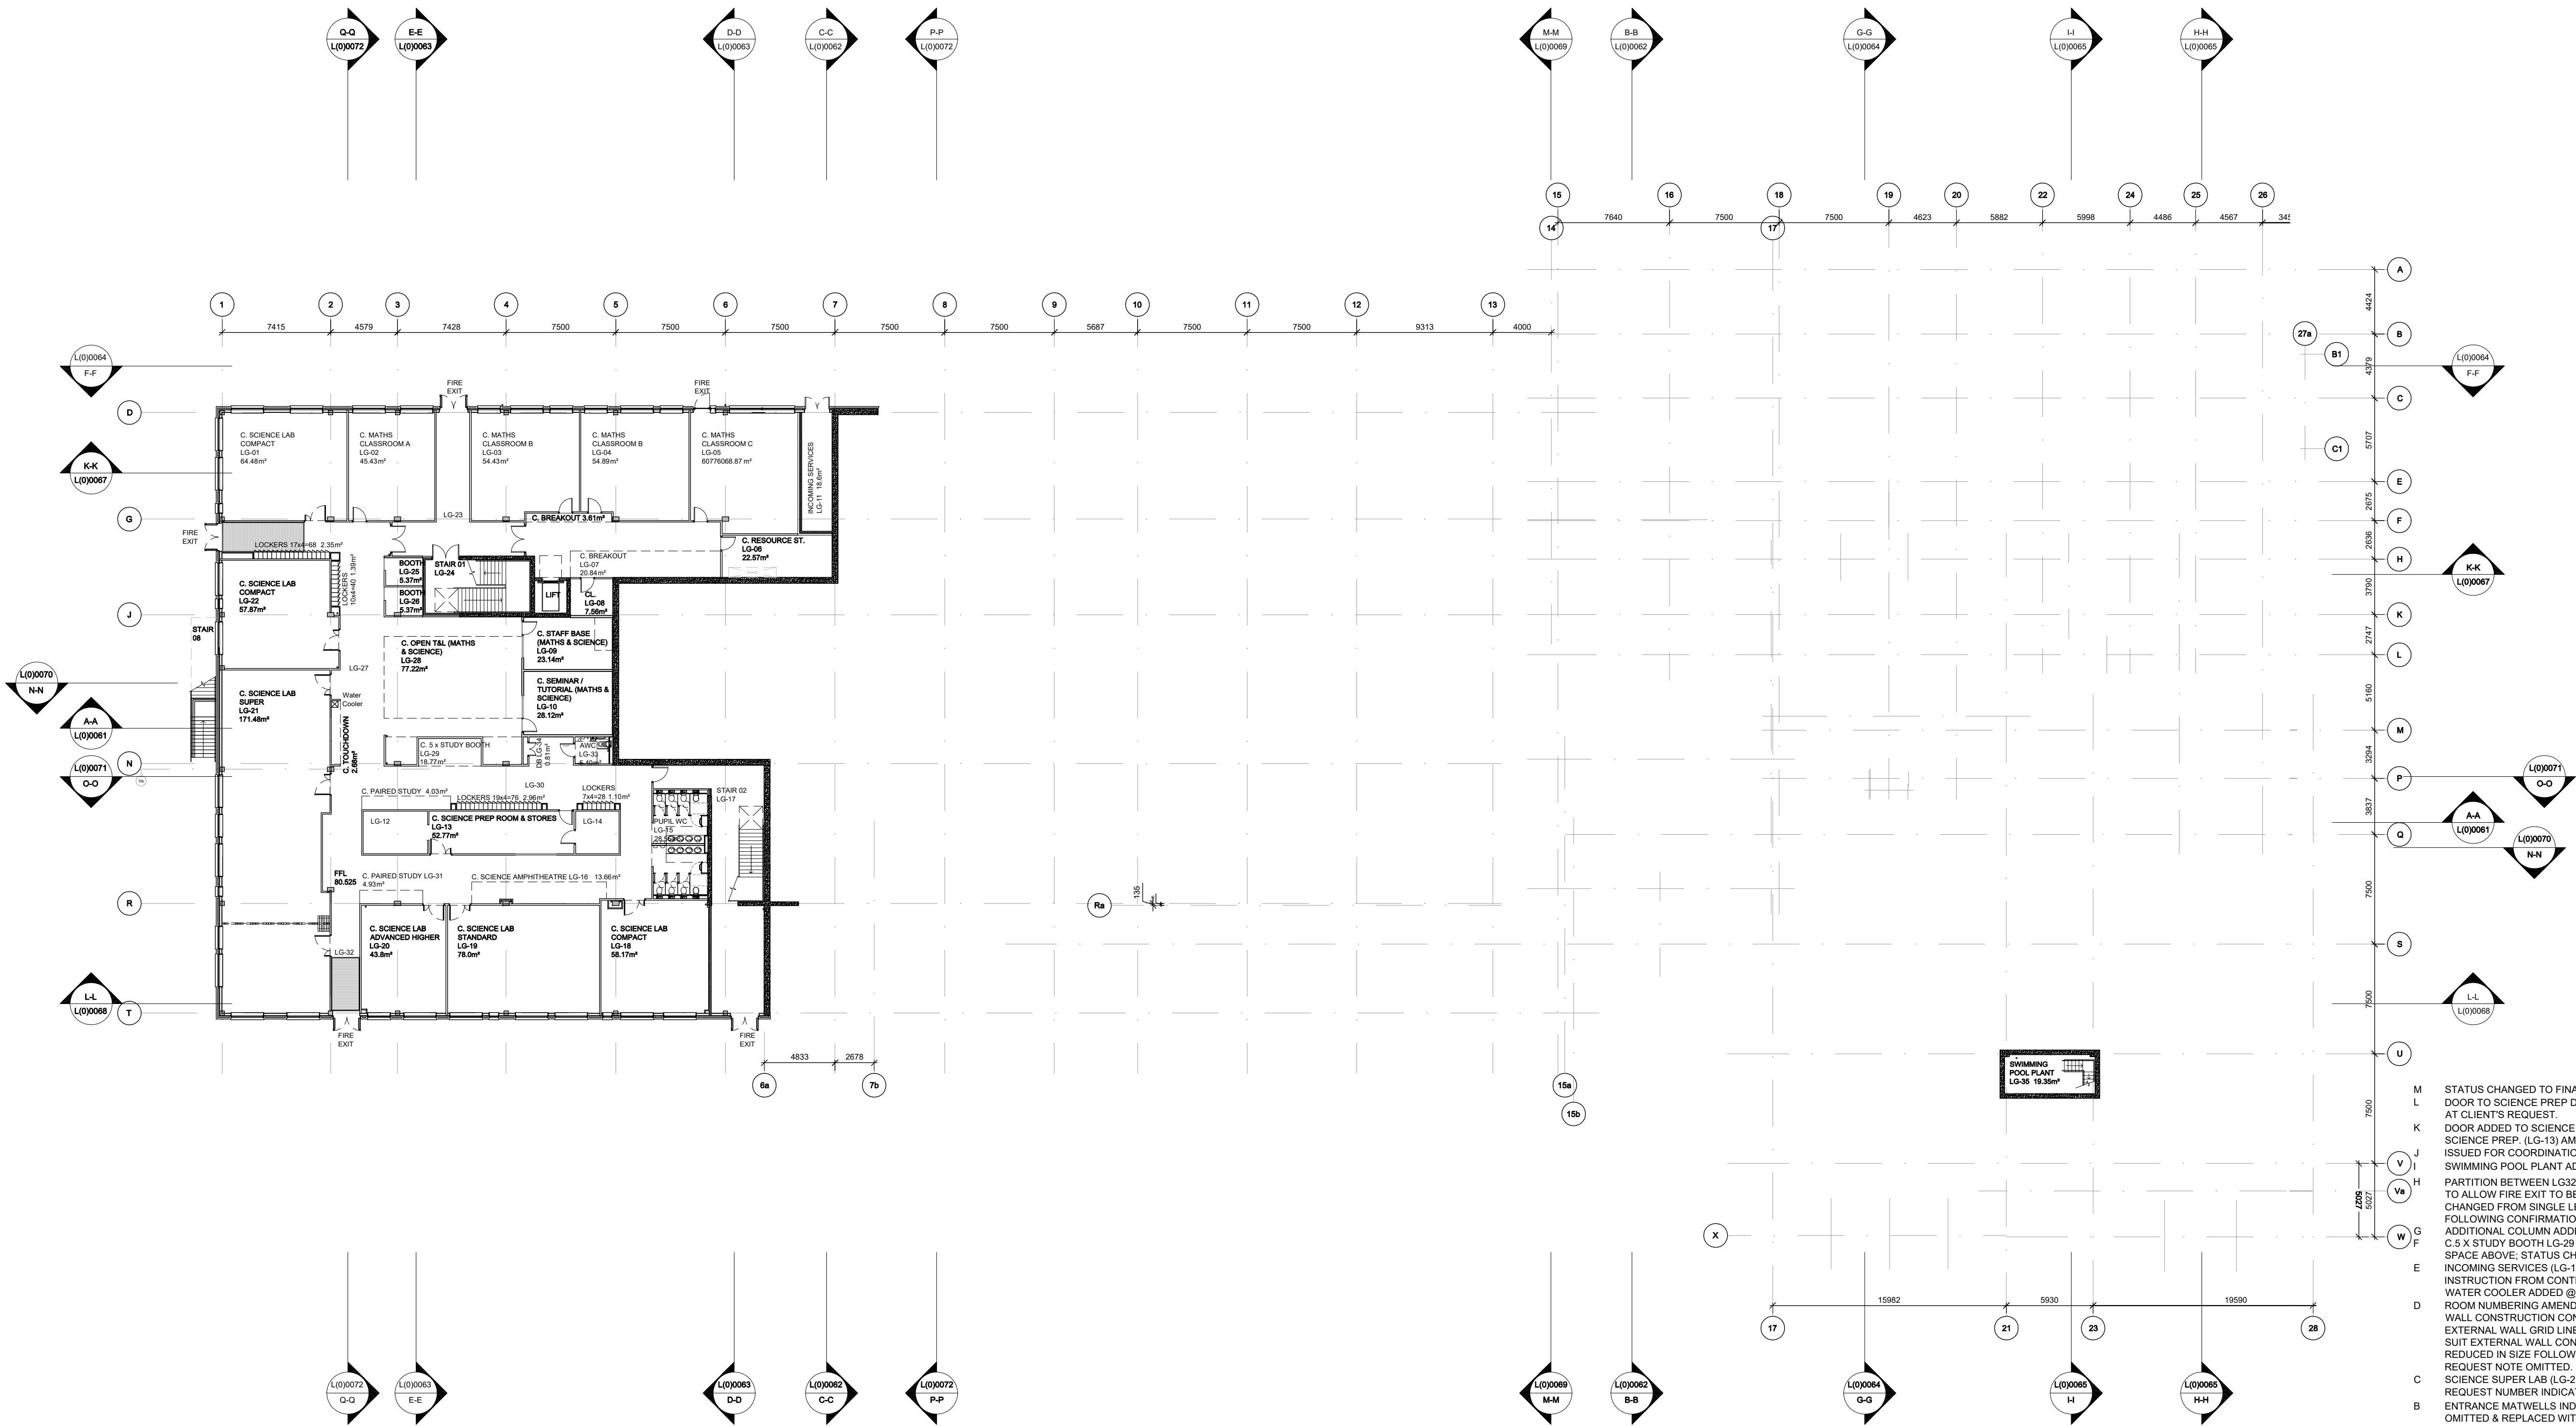
M	STATUS CHANGED TO FINAL CONSTRUCTION.	20.10.15	GJB	RD
L	DOOR TO SCIENCE PREP DOOR (LG-13) CHANGED TO INTERNAL SCREEN AT CLIENT'S REQUEST.	24.07.15	LF	GJB
K	DOOR ADDED TO SCIENCE PREP STORE (LG-14). SLIDING DOOR TO SCIENCE PREP. (LG-13) AMENDED. WALL NIBS ADDED. ISSUED FOR COORDINATION.	29.04.15	LF	GJB
V	SWIMMING POOL PLANT ADDED FOLLOWING INSTRUCTION FROM RCEL.	16.02.15	GJB	
I	PARTITION BETWEEN LG32 & LG20 MOVED TO MAKE CORRIDOR WIDER TO ALLOW FIRE EXIT TO BE A MINIMUM OF 1810mm; STAIR 2 EXIT DOOR CHANGED FROM SINGLE LEAF TO DOUBLE LEAF; LOCKERS AMENDED FOLLOWING CONFIRMATION OF SIZE FROM FF&E SUPPLIER.	10.10.14	AA	GJB
H	ADDITIONAL COLUMN ADDED ON GL 1 BETWEEN GRIDS J AND N.	01.10.14	AA	GJB
G	C.5 X STUDY BOOTH LG-29 AMENDED TO AVOID CLASH WITH VOID SPACE ABOVE; STATUS CHANGED TO CONSTRUCTION.	18.08.14	AA	GJB
F	INCOMING SERVICES (LG-11) REDUCED IN SIZE FOLLOWING INSTRUCTION FROM RCEL; CHANGE REQUEST NOTE OMITTED.	03.07.14	GJB

E	WATER COOLER ADDED @ LG-27.	11.06.14	GJB	
D	ROOM NUMBERING AMENDED & UPDATED TO DB & AWC; EXTERNAL WALL CONSTRUCTION CONFIRMED & UPDATED; WINDOW SIZES UPDATED; EXTERNAL WALL GRID LINES & CONCRETE COLUMNS RELOCATED TO SUIT EXTERNAL WALL CONSTRUCTION; INCOMING SERVICES (LG-11) REDUCED IN SIZE FOLLOWING INSTRUCTION FROM RCEL; CHANGE REQUEST NOTE OMITTED.	30.04.14	GJB	AA
C	SCIENCE SUPER LAB (LG-21) - SLIDING PARTITION BUBBLED & CHANGE REQUEST NUMBER INDICATED; CHANGE REQUEST NOTE ADDED.	20.02.14	GJB	
B	ENTRANCE MATWELLS INDICATED; PUPIL WC (LG-15) - WASH FOUNTAIN OMITTED & REPLACED WITH VANITY UNIT AS PER CLIENT INSTRUCTION; NOTES AMENDED.	08.11.13	GJB	RD
A	ROOM NUMBERS ADDED; STRUCTURAL GRID UPDATED & STRUCTURE INDICATED. MINOR WALL AMENDMENTS TO SUIT STRUCTURE; SERVICE RISERS & DB'S INDICATED; INTERNAL WALLS UPDATED TO REFLECT ACOUSTICIAN'S REPORT; INCOMING SERVICES (LG-11) INCREASED IN SIZE TO MEET SERVICE REQUIREMENTS (AGREED WITH CONTRACTOR); STAFF BASE (LG-09), SEMINAR TUTORIAL (LG-10), STUDY BOOTHS (LG-29), AWC (LG-15), PUPIL WC (LG-15) & STAIR 02 (LG-17) AMENDED; SLIDING FOLDING PARTITION ADDED TO SCIENCE SUPER LAB (LG-21) FOLLOWING CLIENT INSTRUCTION; DEPARTMENT COLOURS OMITTED.	08.11.13	AA/SM	GJB

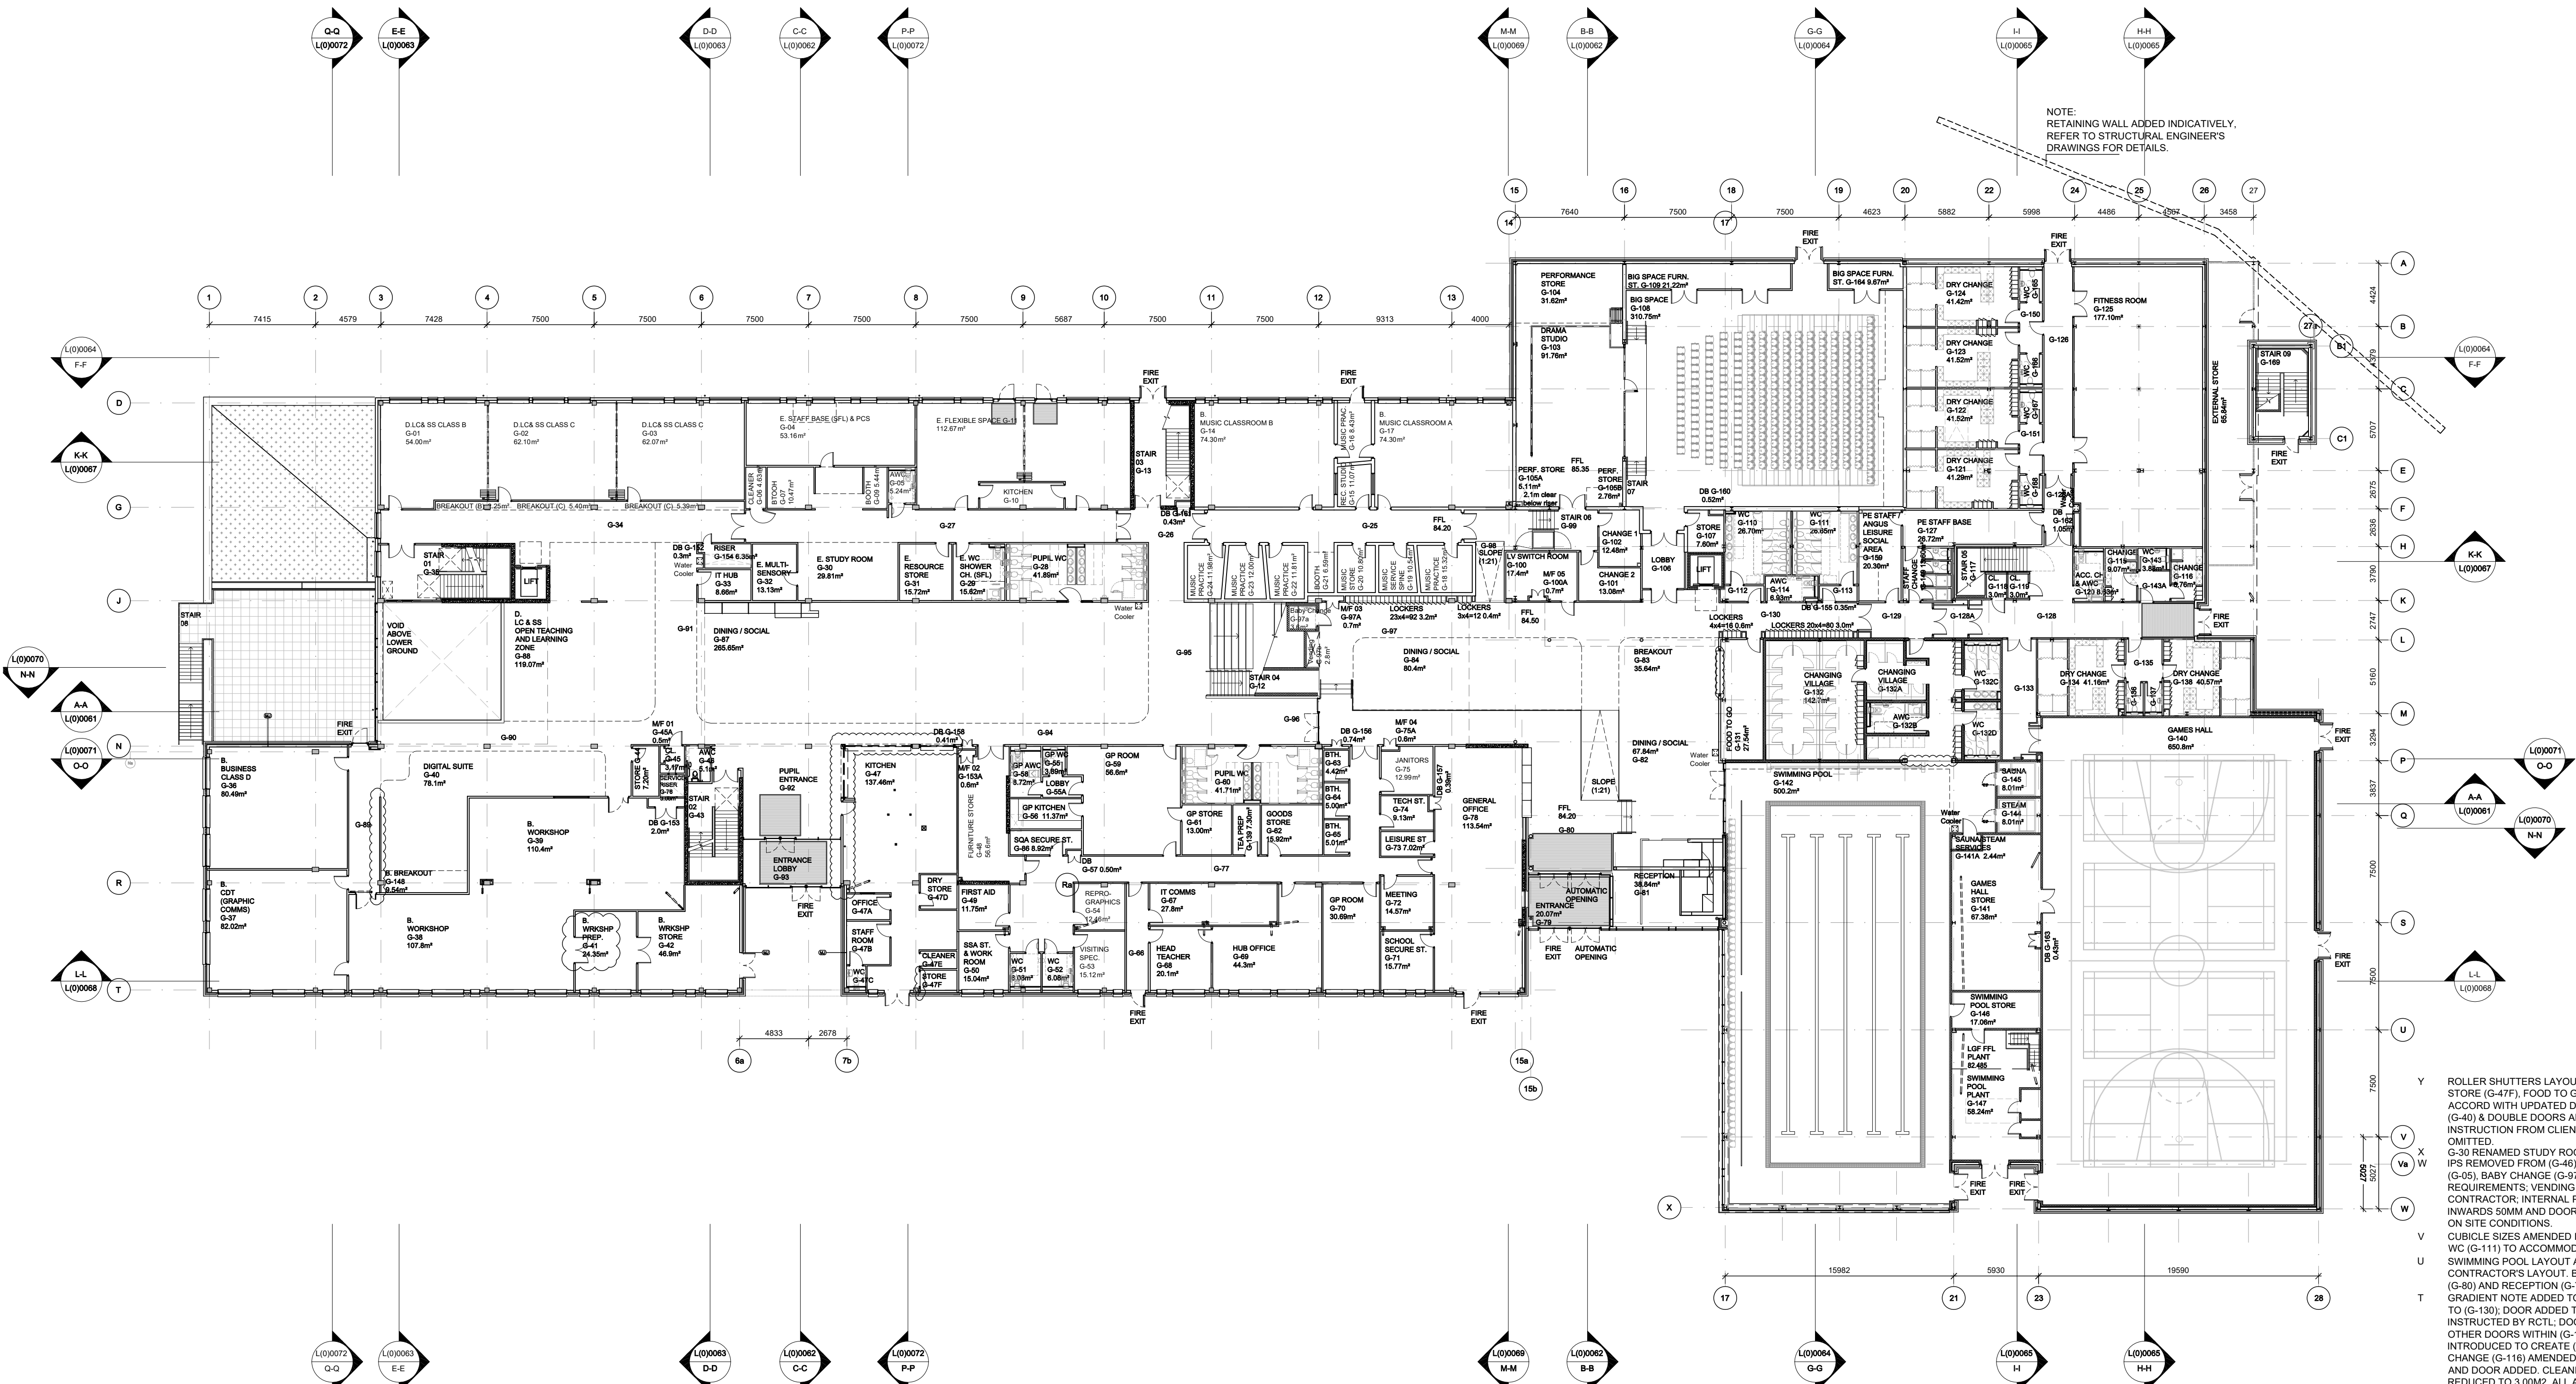
Y	ROLLER SHUTTERS LAYOUT UPDATED WITHIN KITCHEN (G-47), KITCHEN STORE (G-47F), FOOD TO GO (G-131) & SWIMMING POOL (G-142) TO ACCORD WITH UPDATED DETAILS. PARTITION ADDED TO DIGITAL SUITE (G-40) & DOUBLE DOORS ADDED TO WORKSHOP PREP (G-41) AS PER INSTRUCTION FROM CLIENT/CONTRACTOR; REVISION NOTES P-R OMITTED.	25.08.15	GJB/LF	GJB
U	CUBICLE SIZES AMENDED IN COMMUNITY WC (G-110) AND COMMUNITY WC (G-111) TO ACCOMMODATE STEEL BRACING.	15.07.15	GJB	GM
V	SWIMMING POOL LAYOUT AMENDED IN ACCORDANCE WITH SUB CONTRACTOR'S LAYOUT. BUILD UP OF WALL BETWEEN ENTRANCE (G-80) AND RECEPTION (G-78) UPDATED.	30.06.15	LF	GJB
T	GRADIENT NOTE ADDED TO (G-98); LOCKERS RELOCATED FROM (G-133) TO (G-130); DOOR ADDED TO SWIMMING POOL PLANT ROOM (G-147) AS INSTRUCTED BY RCTL. DOORS ADDED TO CREATE LOBBY (G-126A). OTHER DOORS WITHIN (G-126A) RE-LOCATED. ADDITIONAL DOORS INTRODUCED TO CREATE (G-128A). LAYOUT TO CHANGE (G-115) AND CHANGE (G-116) AMENDED TO ALLOW WC (G-143) TO BE RE-LOCATED AND DOOR ADDED. CLEANER'S CUPBOARDS (G-118) AND (G-119) REDUCED TO 3.00M2, ALL AS PER BUILDING CONTROL REQUIREMENT. TUITION ROOM (G-68) OMITTED AND STAFF BASE (SFL) & PCS (G-04) EXTENDED. DOOR TO TUITION ROOM (G-06) SUBSEQUENTLY REMOVED. NUMEROUS ROOM TYPES RELOCATED FOLLOWING INSTRUCTION FROM CLIENT; TECH ST. (G-50) TO SSA ST. AND WORK ROOM (G-50); VISIT SPEC (G-53); VISIT SPEC. (G-54) TO REPROGRAPHICS (G-54); PCS (G-70) TO GP ROOM (G-70); SSA ST. & WORK ROOM (G-71) TO SCHOOL SECURE ST. (G-71); REPROGRAPHICS (G-72) TO MEETING (G-72); SCHOOL SECURE STORE (G-74) TO TECH ST. (G-74) AND GP MEETING (G-75) TO JANITORS (G-75); MEETING (G-72); LEISURE ST. (G-73) AND GENERAL OFFICE (G-78) DOORS RELOCATED.	29.04.15	LF	GJB
